Current Zoning: N1-A (neighborhood 1-A)  
Proposed Zoning: UR-2(CD) (urban residential, conditional)

Approximately 4.2 acres located on the north side of Galloway Road, east of Mallard Creek Road, and west of Garrison Road.

The petition proposes a residential community of up to 28 single-family attached dwelling units.

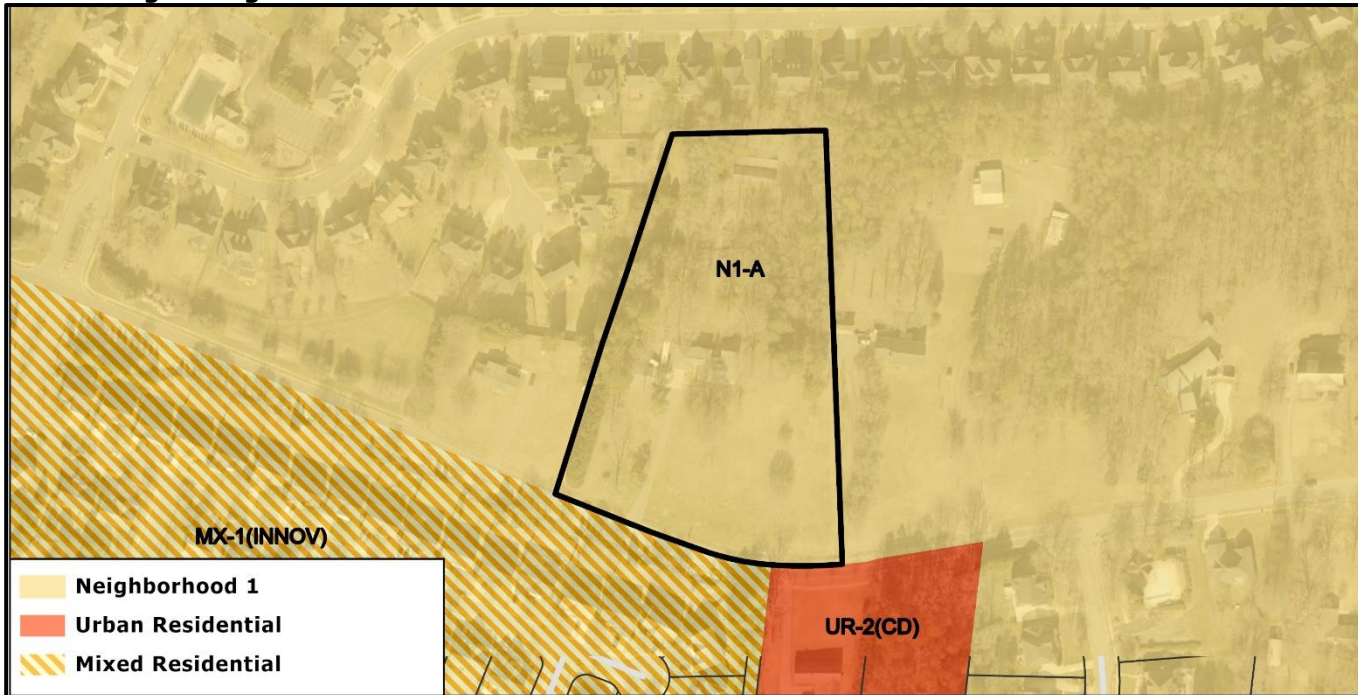
1. Remove "visible from", changing to "proposed along" to read: "Garage doors proposed along public..." for architectural note 8. **Addressed**
2. The setback in the site data table says 35' from BOC. please show correct setback. **Addressed**
3. The rear yard in site data table say 10'. Please add or 20' as shown. **Addressed**
4. Change the height in site data table to say 40', with allowance up to 48' per 9.406(2)(a) **Addressed**
5. Change architectural note 5 from 4 units to 3 units fronting Galloway Road. **Addressed**
